**Product Change Notification
Software Release Notice**

MultiConnect[®] rCell 100 Series Cellular Routers

**mPower[™] Edge Intelligence
Now Available - mPower 5.3.X Firmware**

Product Change Notification (PCN) Number
PCN 12142020-001 (mPower - MTR)

API Command Changes (MTR 5.3.X):

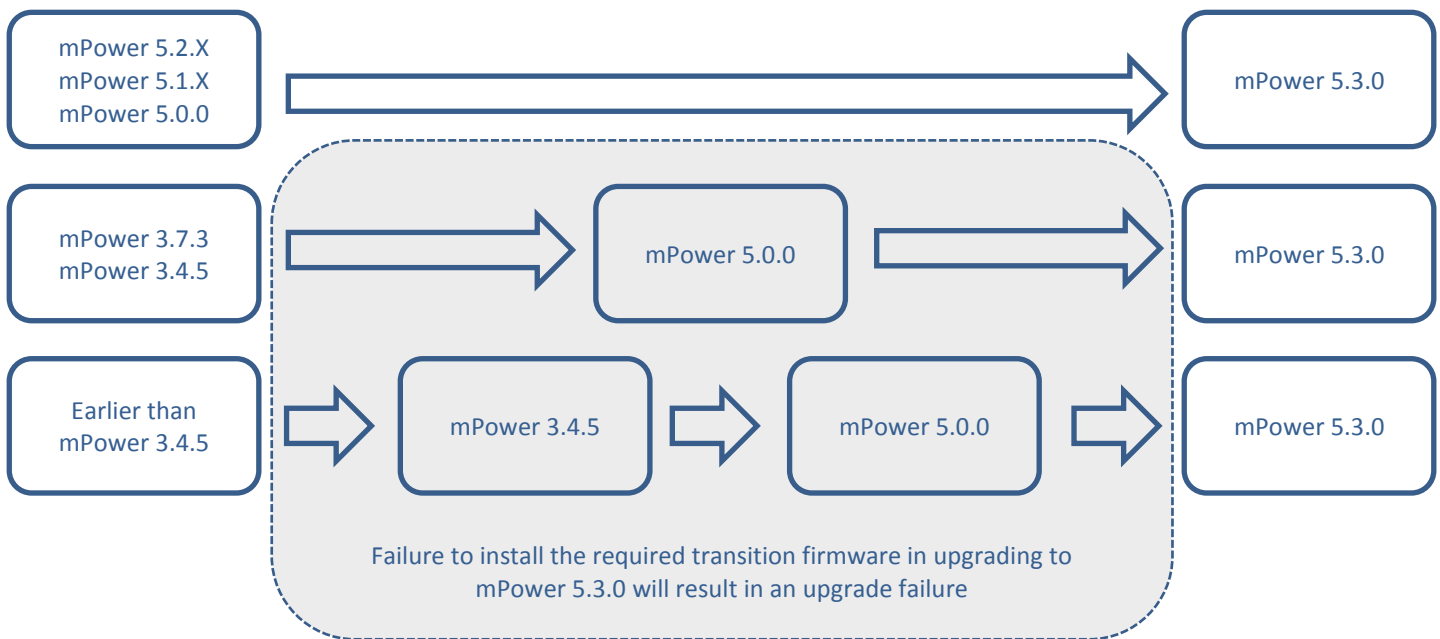
The MultiConnect rCell 100 Series Router uses the RESTful JSON API for managing configurations, polling statistics, and issuing commands. mPower MTR 5.3.X versions include a number of API changes.

Changes from mPower 5.2.x to mPower 5.3.X:

<http://www.multitech.net/developer/software/mtr-software/mtr-api-reference/api-changes/>
